**COUNTY OF SAN MATEO
PLANNING AND BUILDING DEPARTMENT**

SUBJECT: EXECUTIVE SUMMARY: Consideration of an appeal of the San Mateo County Community Development Director's approval of an "After-the-Fact" staff-level Coastal Development Permit (CDP), for the unauthorized removal of vegetation (PLN 2016-00264 and VIO 2016-00141) and the Coastside Design Review Permit (PLN 2016-00337), pursuant to Sections 6328.4 and 6565.3 of the San Mateo County Zoning Regulations, respectively, to allow construction of a new two-story 3,546 sq. ft. single-family residence with an attached 487 sq. ft. two-car garage, including a 1,152 sq. ft. second unit with a detached 400 sq. ft. carport, on an existing 22,337 sq. ft. legal parcel (recorded Certificate of Compliance (PLN 2015-00444). The second unit is a ministerial project and is not subject to Planning Commission review. Seventeen (17) existing significant trees are proposed for removal associated with the construction of the new residence, in addition to those already removed. The project is not appealable to the California Coastal Commission.

County File Number: PLN 2016-00337 and PLN 2016-00264 (Peterson)

EXHIBIT-C

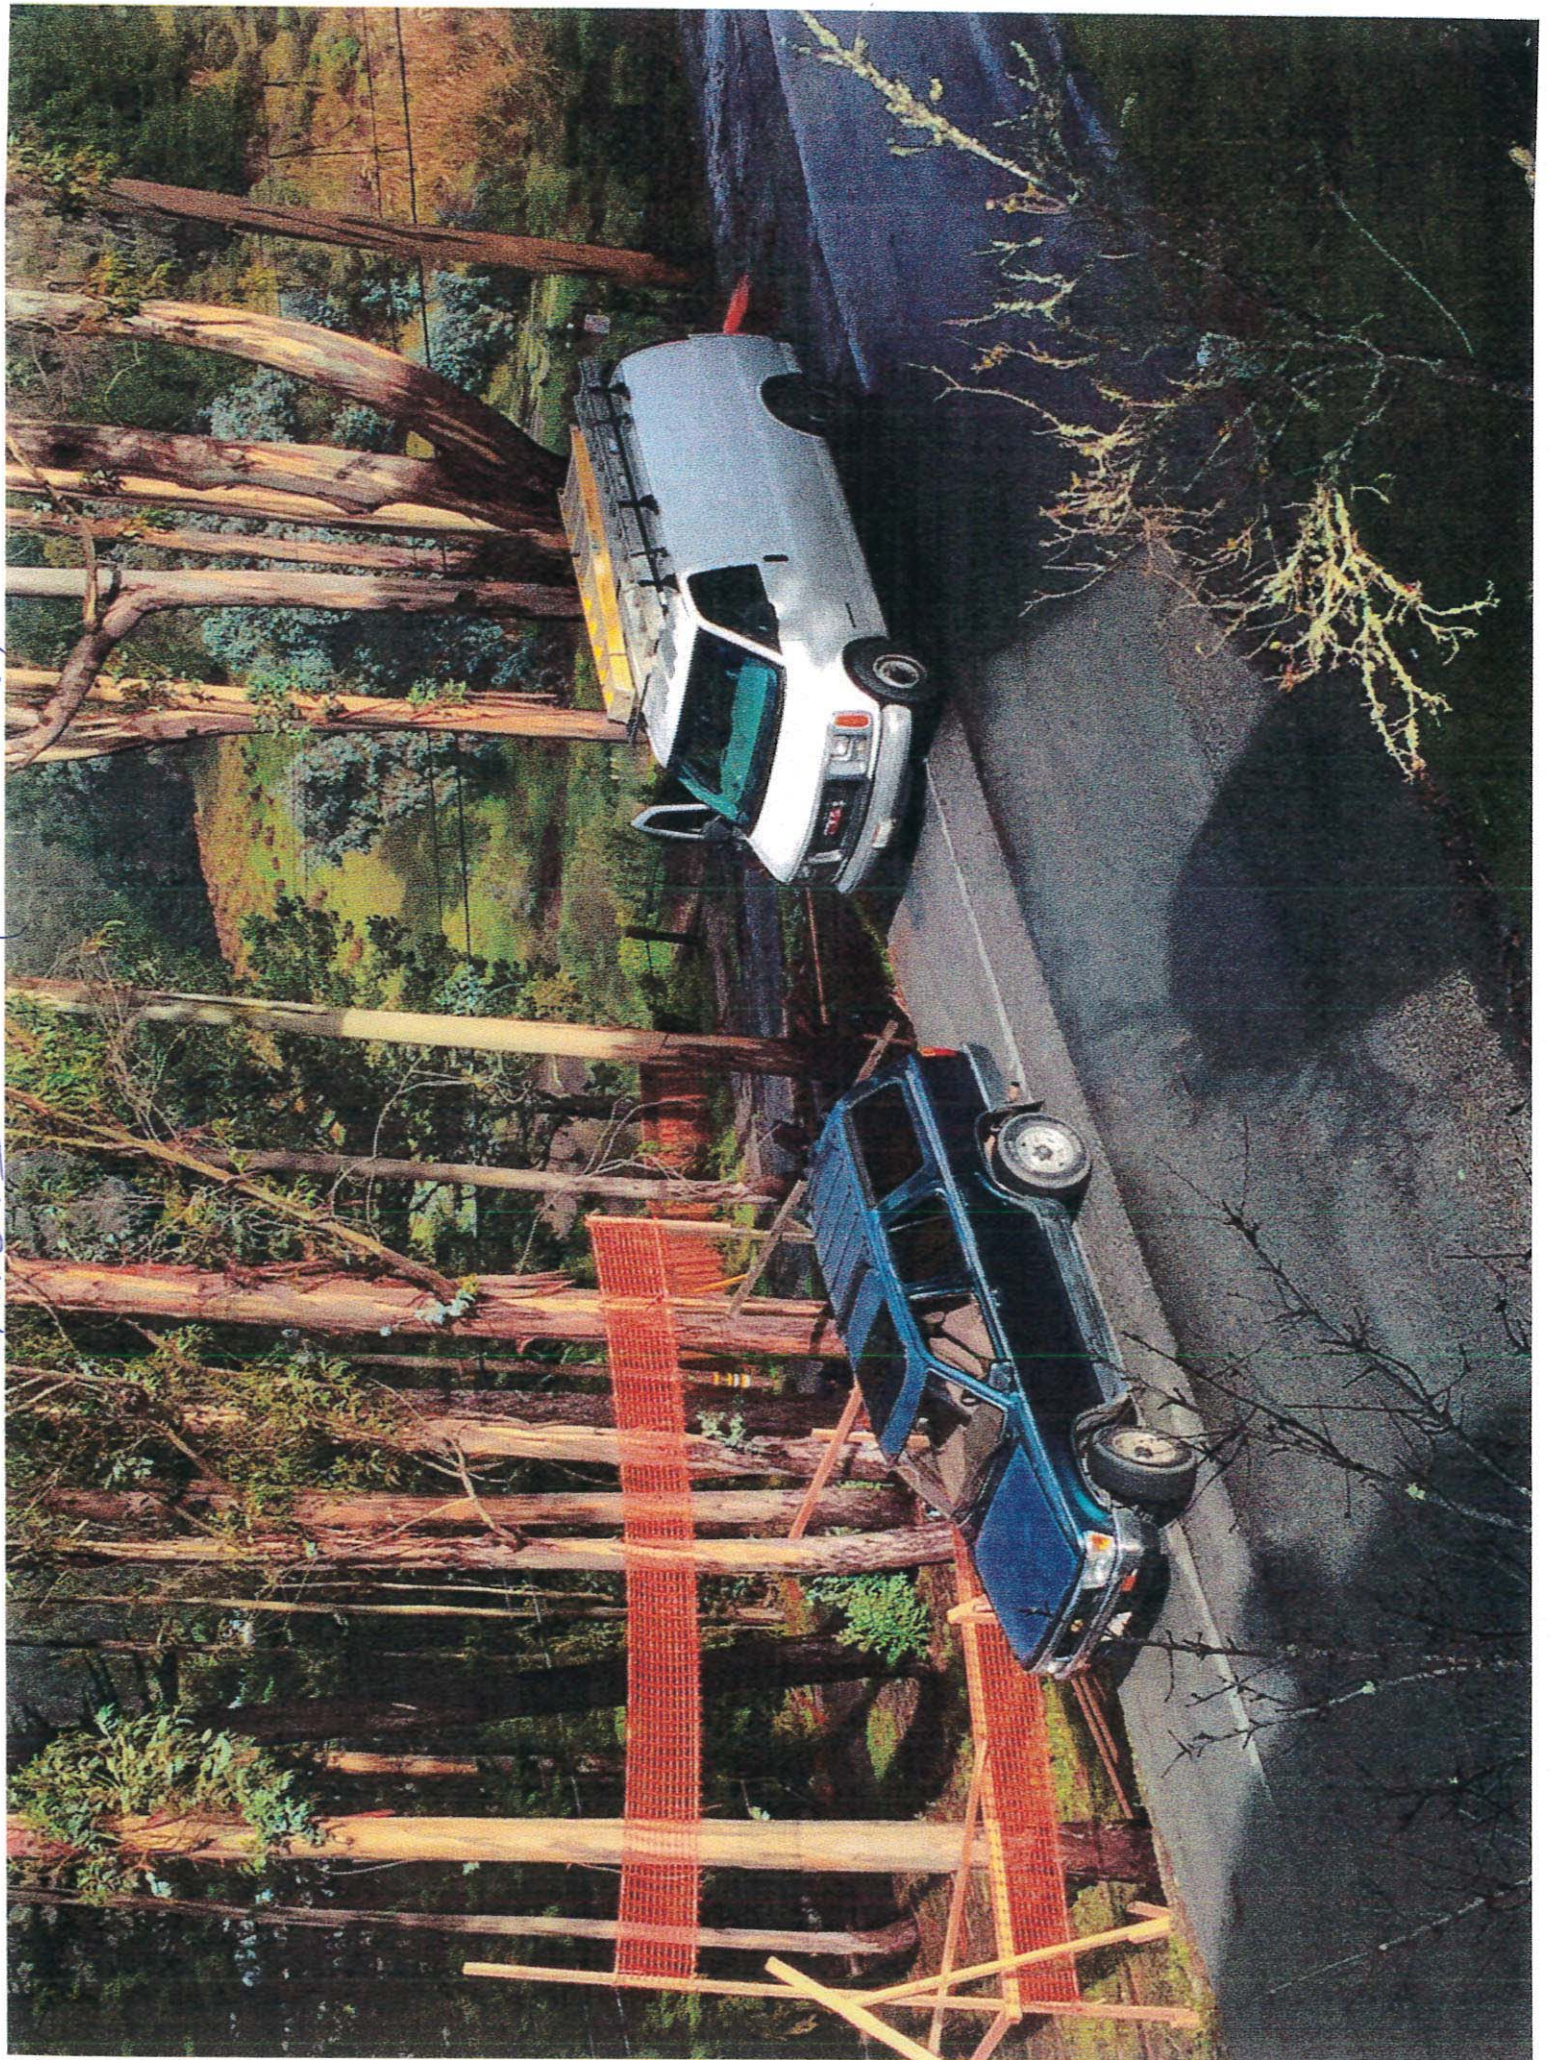
1. The Appellant asserts that the project is being built on the very weak edge of Terrace Avenue and the owner is using this weak edge of Terrace Avenue as the only primary access to his property upon project completion. The Appellant asserts that a condition of approval requiring a continuous retaining wall along APN 048-072-290 adjoining Terrace Avenue should be included in the project approval. The Appellant states that the owner already plans to build a retaining wall along a part of Terrace Avenue and his property and that the owner needs to make it continuous and all along his property and Terrace Avenue. The Appellant asserts that the photos (Attachment D) show the fragile condition of Terrace Avenue along the project site.

Staff's Response: The applicant proposes to shore up the front portion of the property along Terrace Avenue with retaining walls as shown on Page C-2.0 of Attachment C. The project has been reviewed by Department of Public Works (DPW) staff. The proposed access improvements, as included in the civil plans included in Attachment C, have been found to be adequate and have been preliminarily approved by DPW Staff. The additional requested improvements are not included in the condition of approvals and are outside of the scope of the project. The applicant is working with neighbors that use Terrace Avenue to prepare a private maintenance agreement to address ongoing maintenance of the road.

EXHIBIT-D

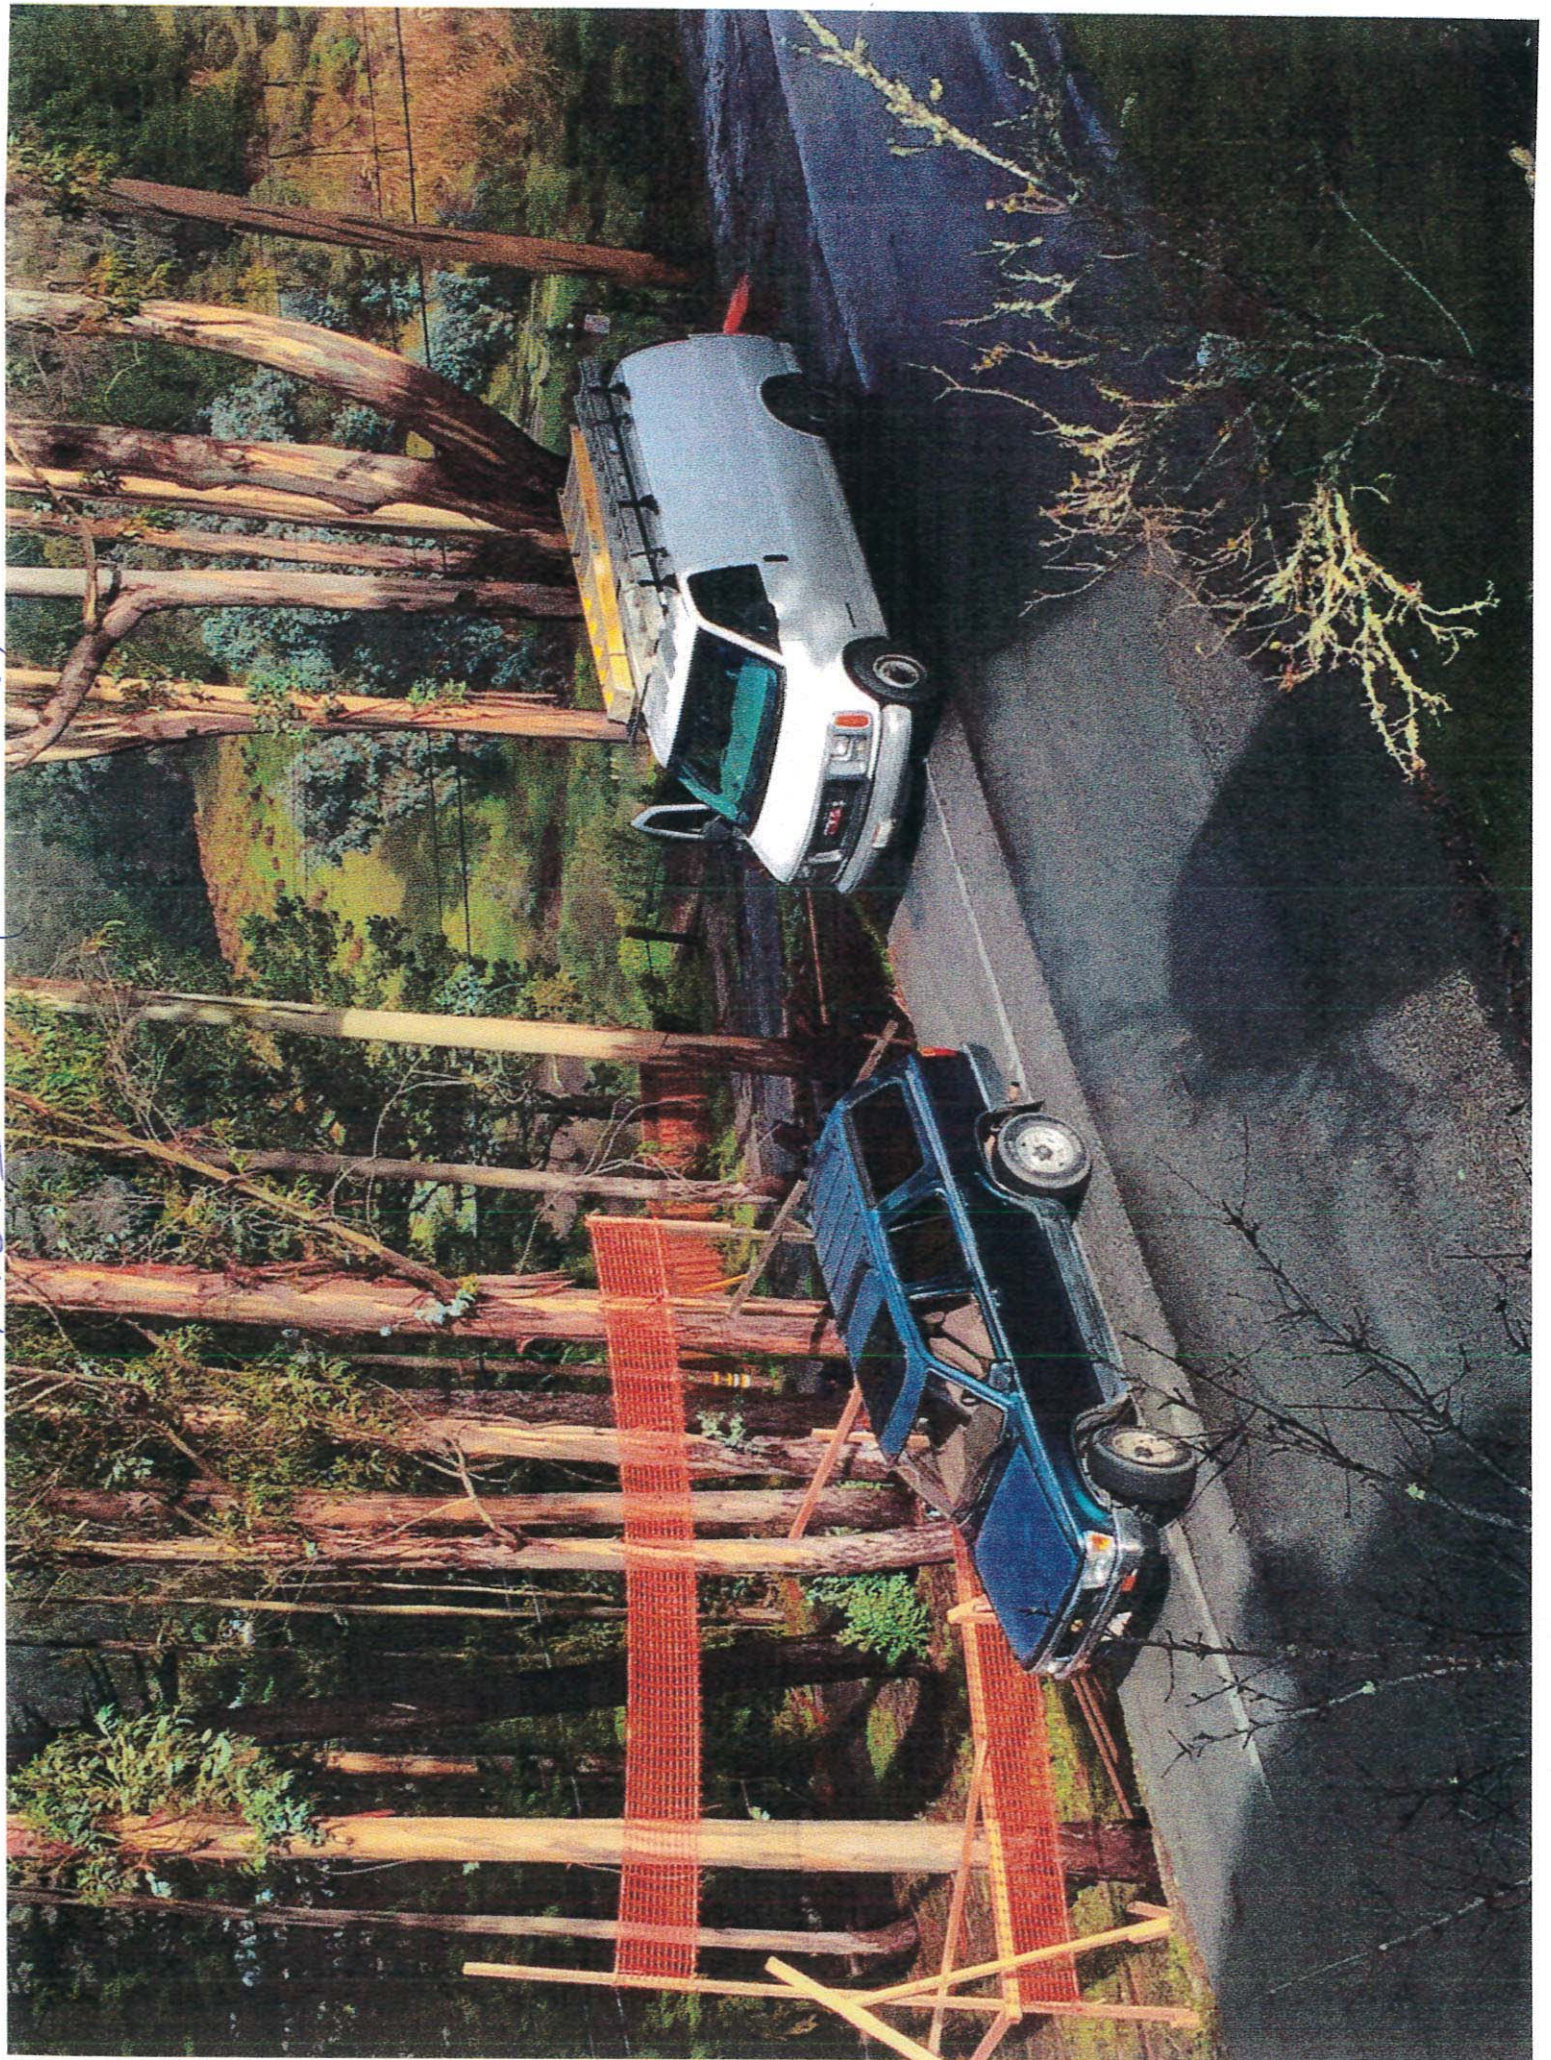
- ② THE RECENT REMOVAL OF TREES AND VEGETATION AND THE ^{PRESENCE OF} CONSTRUCTION TRUCKS OF APN: 048-072-290 OWNER, AS SHOWN IN EXHIBIT-D, HAS MADE TERRACE AVE EDGE ALONG APN 048-072-290 WORSE. A FIRE TRUCK WOULD NOT BE ABLE TO SERVICE ~~THAT~~ HERE EITHER AS CAN BE SEEN IN EXHIBIT A, B, C.
- ③. THE PERMISSION IN THE COUNTY LETTER OF JUNE 22, 2017 TO REMOVE ADDITIONAL TREES & VEGETATION WILL FURTHER DETERIORATE THE CONDITION OF TERRACE AVE.
- ④ THE OWNER OF APN: 048-072-290 IS ALREADY BUILDING A RETAINING WALL ALONG A PART OF TERRACE AVE & HIS PROPERTY. HE JUST NEEDS TO MAKE IT CONTINUOUS AND ALL ALONG HIS PROPERTY AND TERRACE AVE.
- ⑤ APN: 048-072-290 IS ^{BEING BUILT} ON THE VERY WEAK EDGE OF TERRACE AVE AND THE OWNER OF APN: 048-072-290 IS USING THIS WEAK EDGE OF TERRACE AVE AS THE ONLY & PRIMARY ACCESS TO HIS PROPERTY ON COMPLETION.

Staff's Response: The Coastside Fire Protection District (CFPD) has reviewed the project and provided conditions of approval that require a maintained asphalt surface road for ingress and egress of fire apparatus which, in this case, pertains to the private road. The removal of vegetation has been approved and will not impact the stability of the road.
